IFB 233058: ADDENDUM NO. 2
Amendments/Changes/ Clarification

Project: HPCS-4 Power & Cooling

IFB ISSUE DATE: January 31, 2013
CLOSING DATE: February 22, 2013

PARTIAL FLOOR PLAN - FINISHED PLAN PIPING

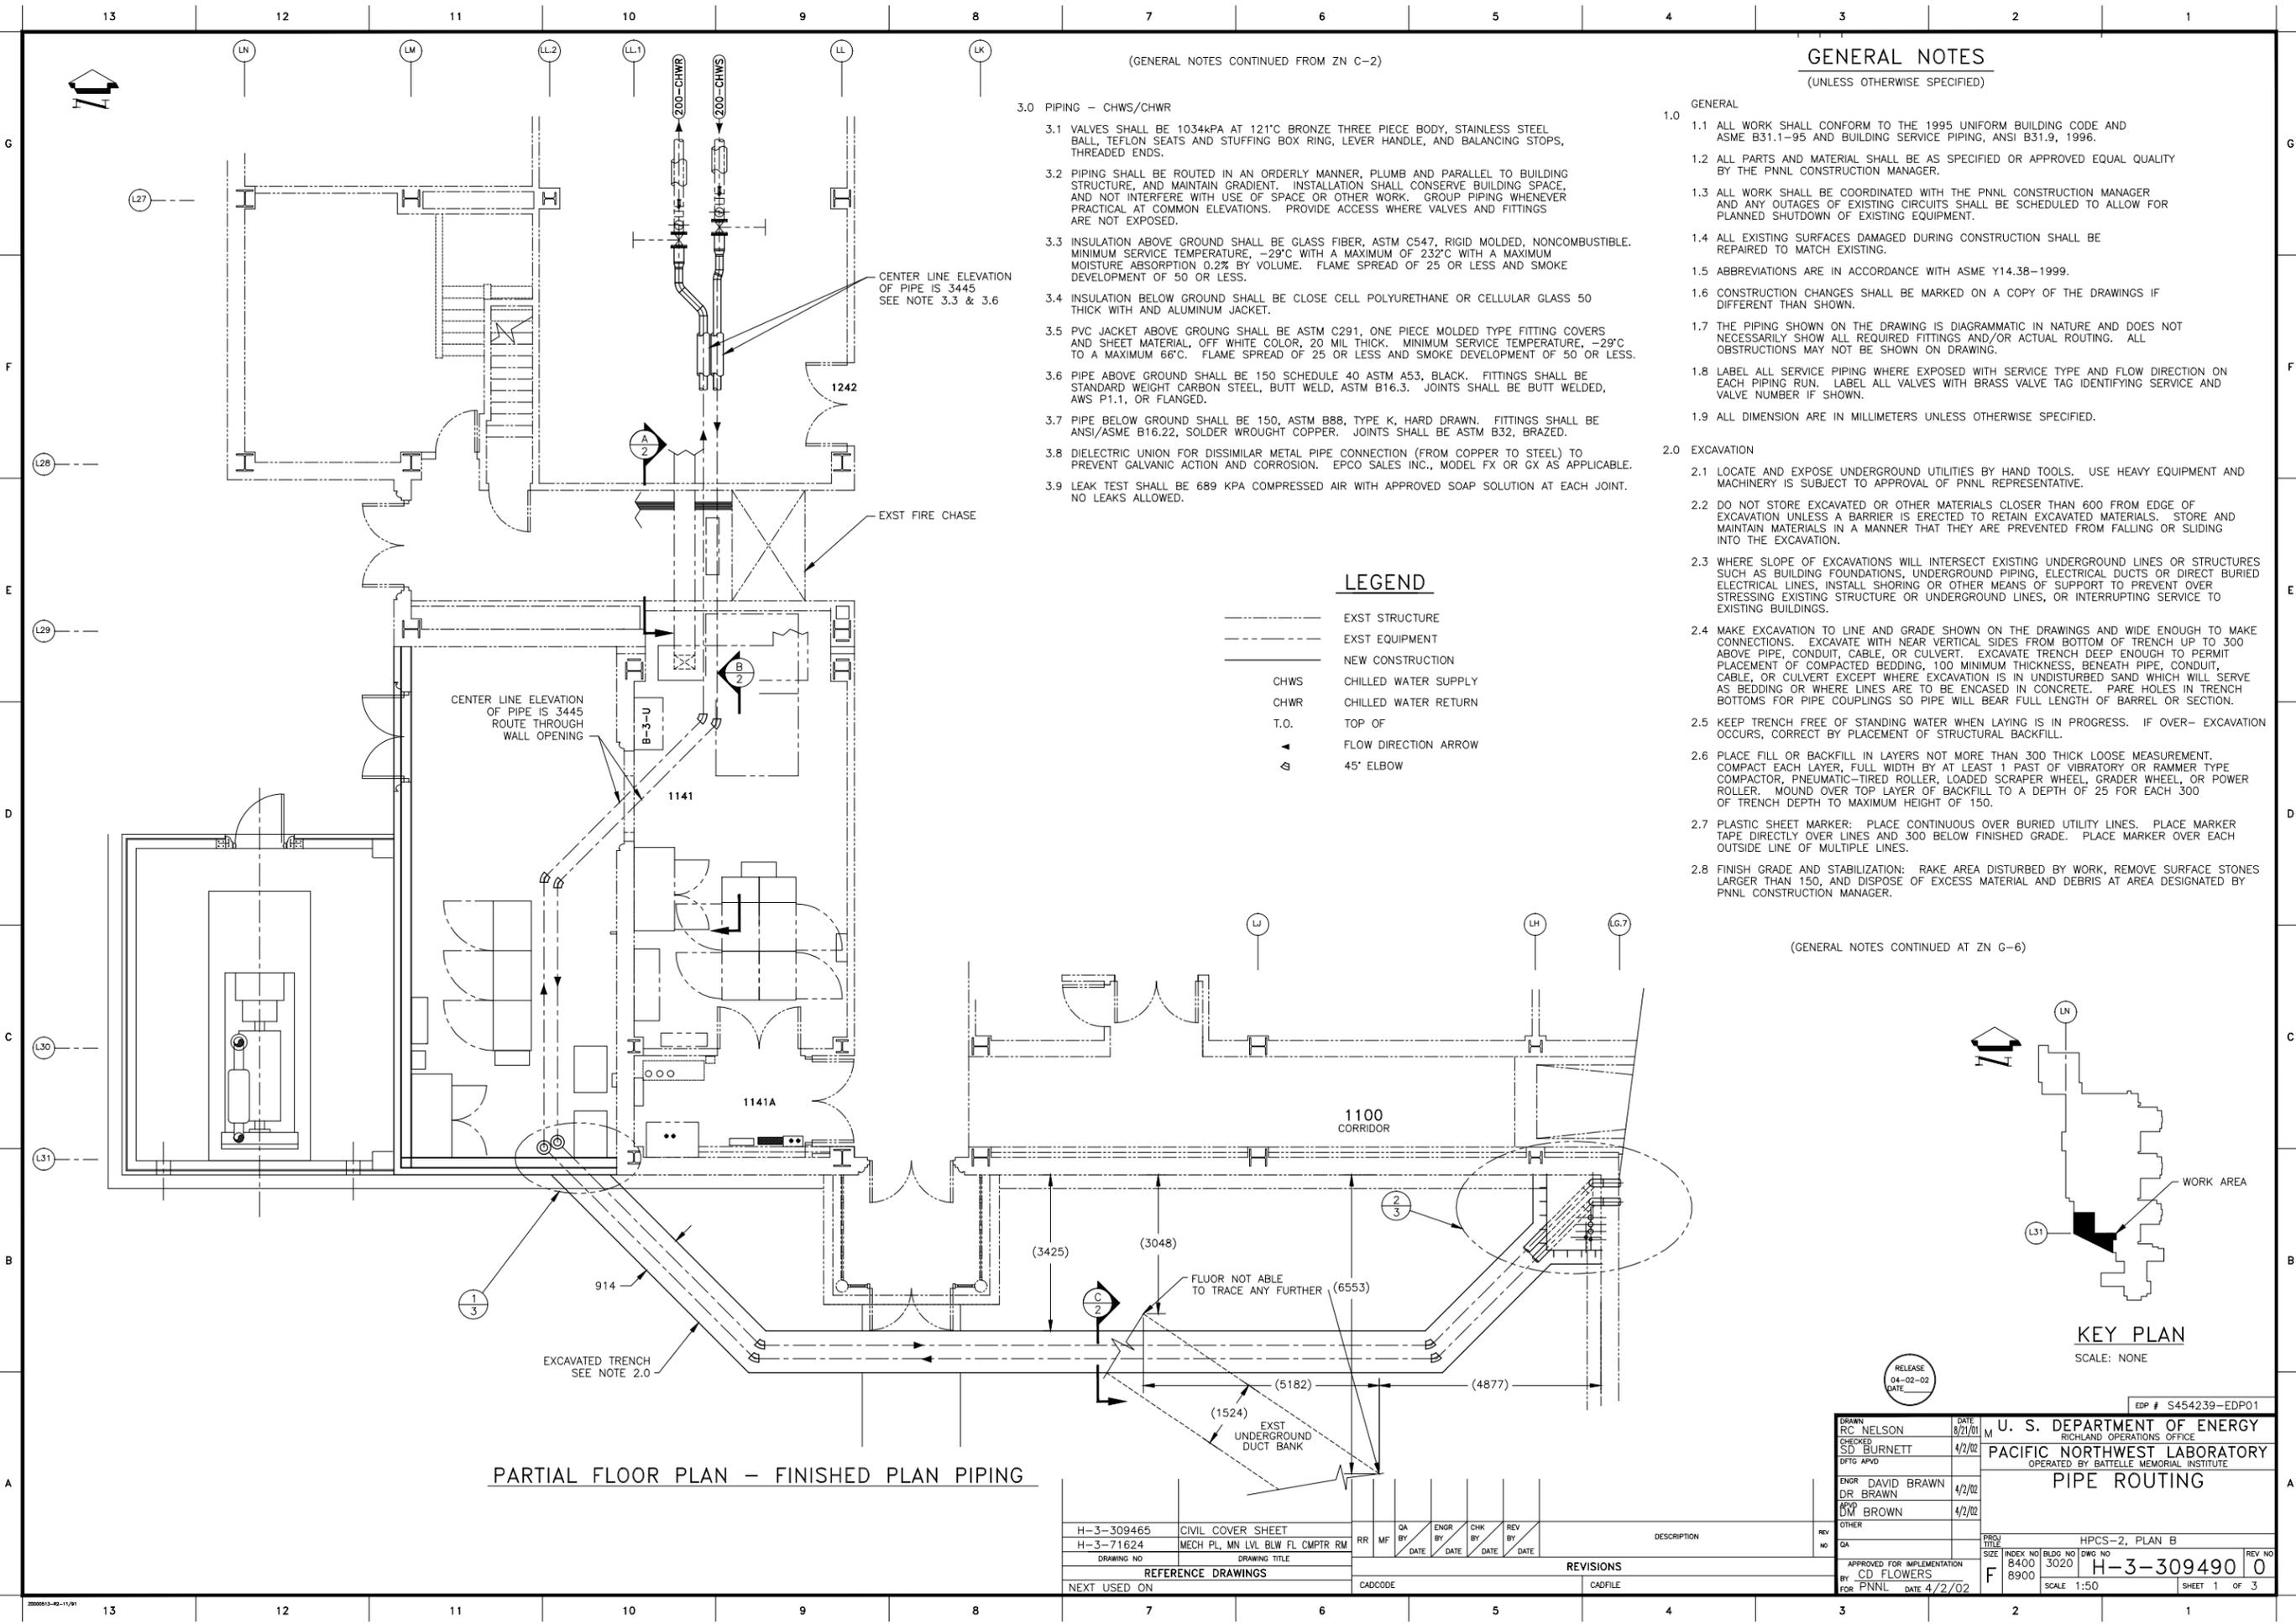
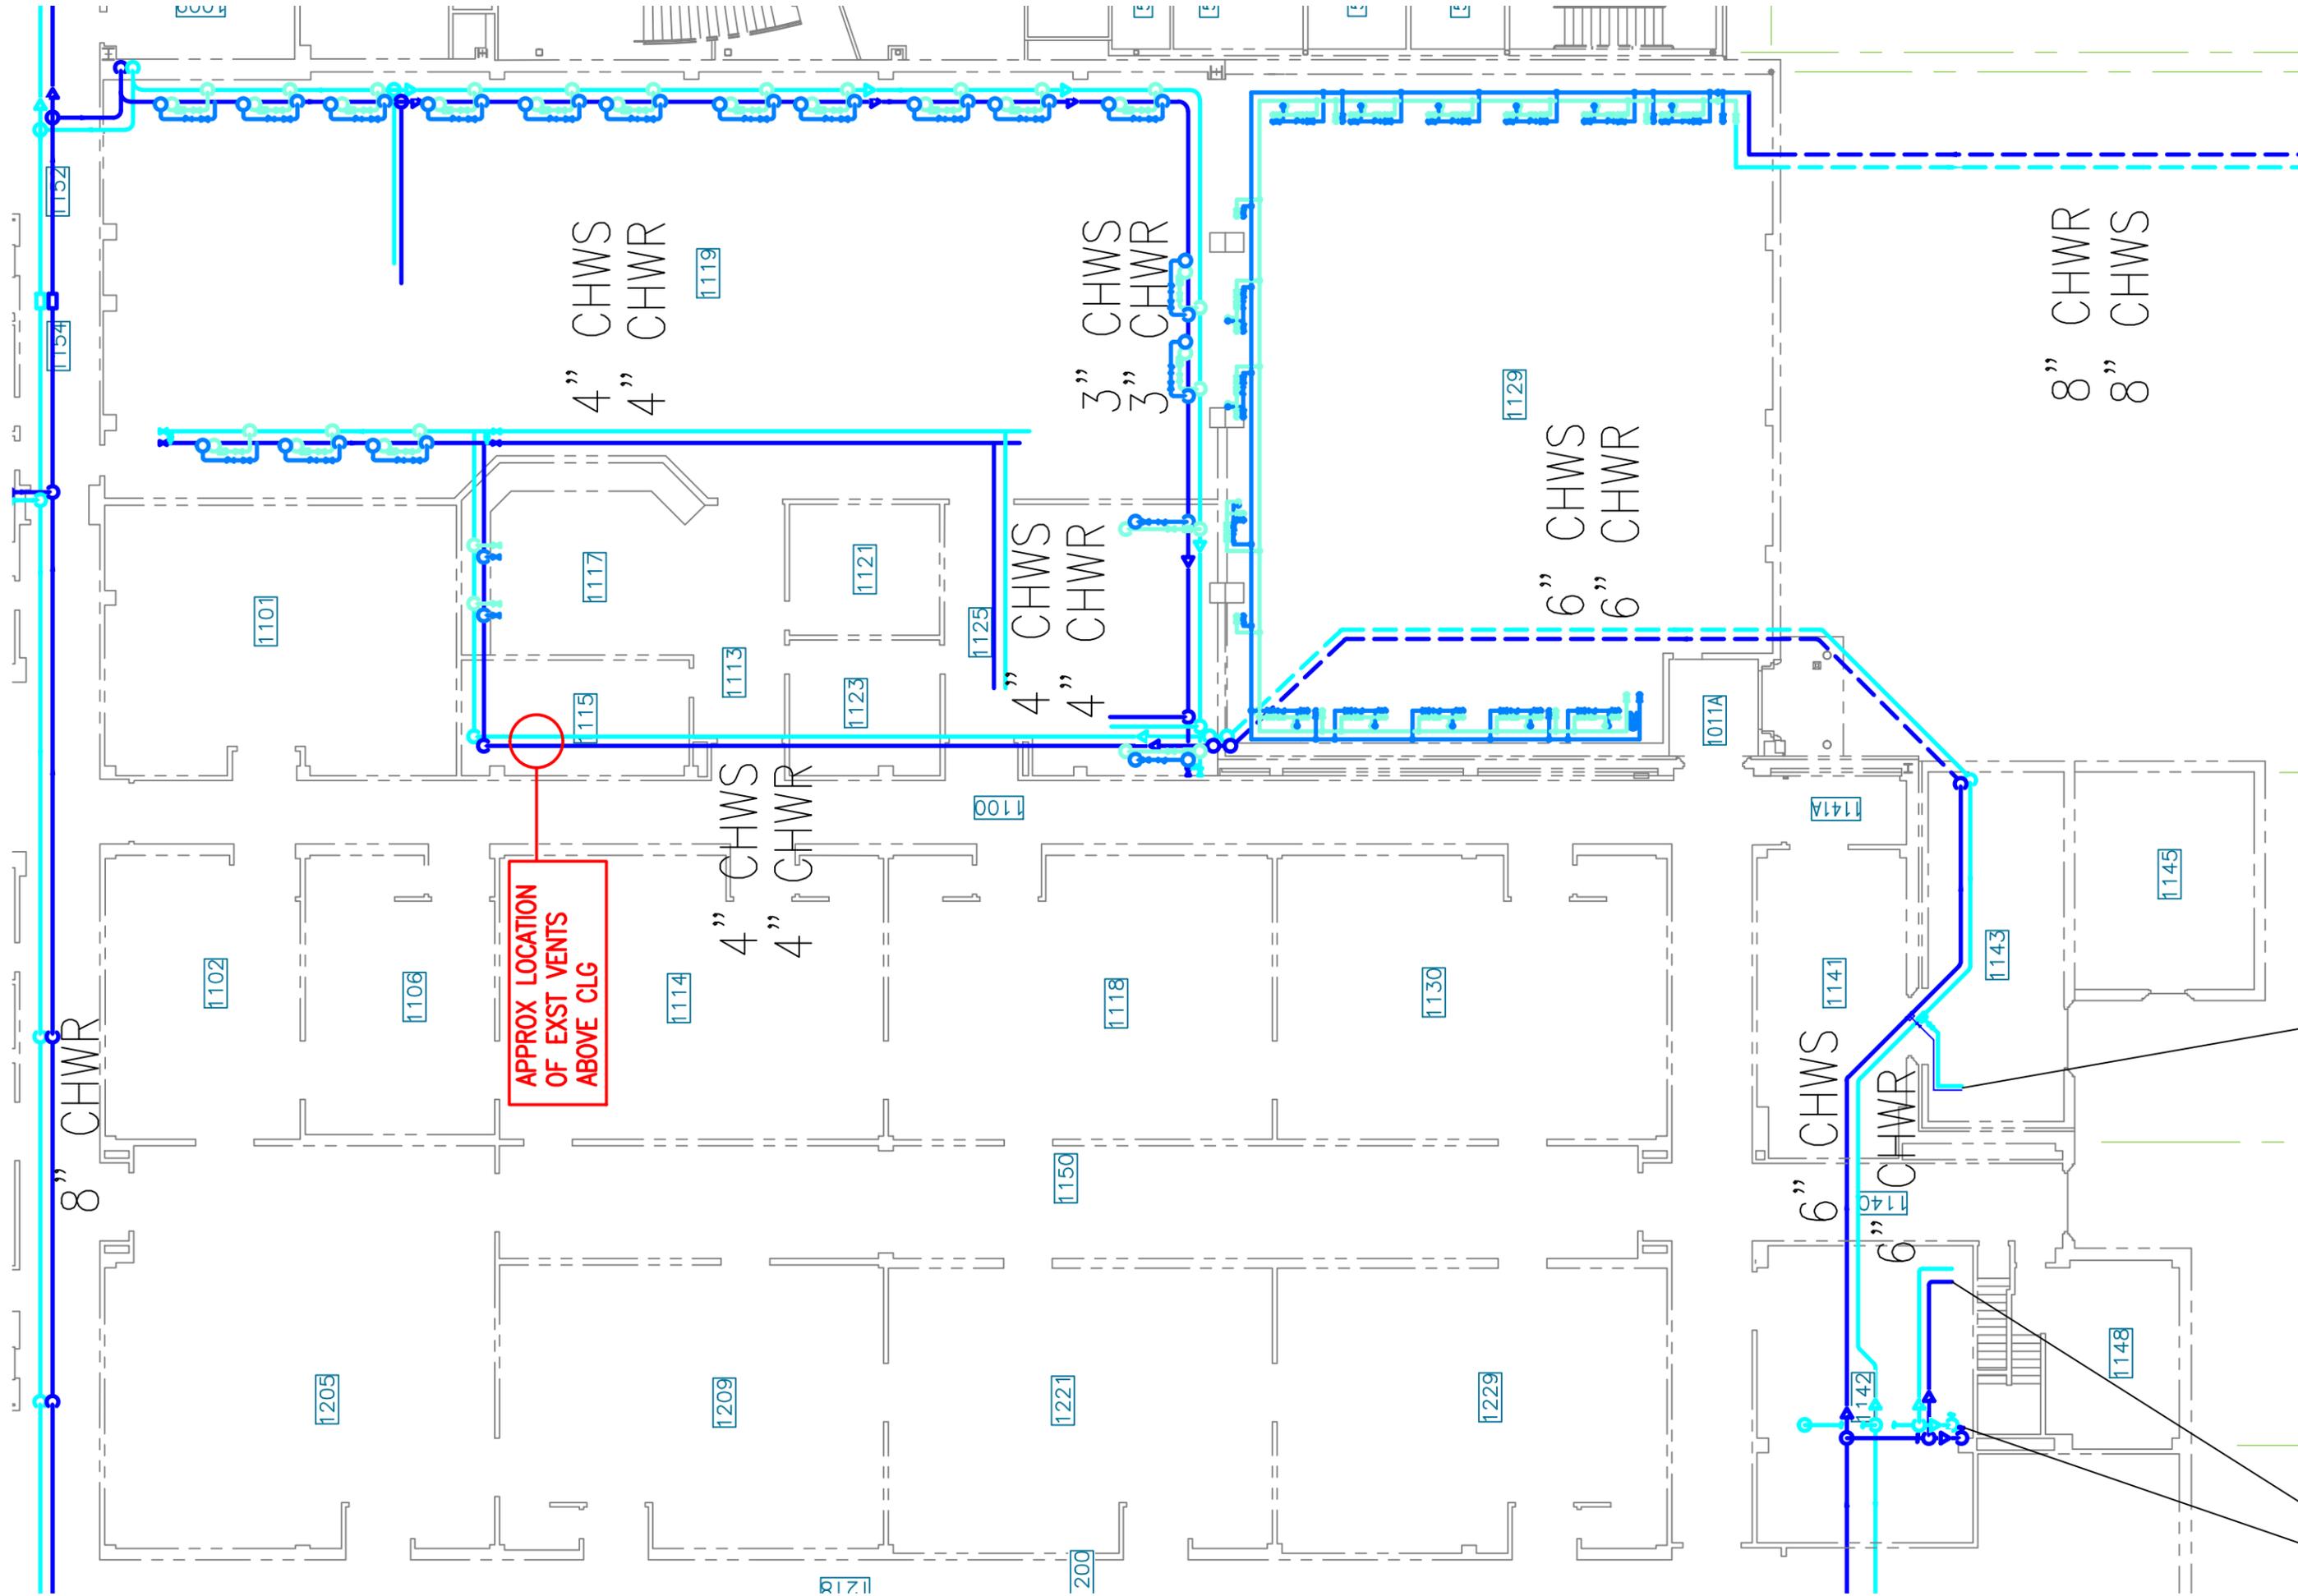
1. Sheet WS9614 2 of 3 note 1 Directs the contractor to provide cap and valves on existing 4" chilled water. Where are the nearest isolation valves located on the existing (2) supply and (2) return lines that are shown (This will determine how much fluid needs to be captured).
Ans: Attached are building drawings of the 4" chilled water line to be isolated. The Isolation valves for the line are in Room 1142.
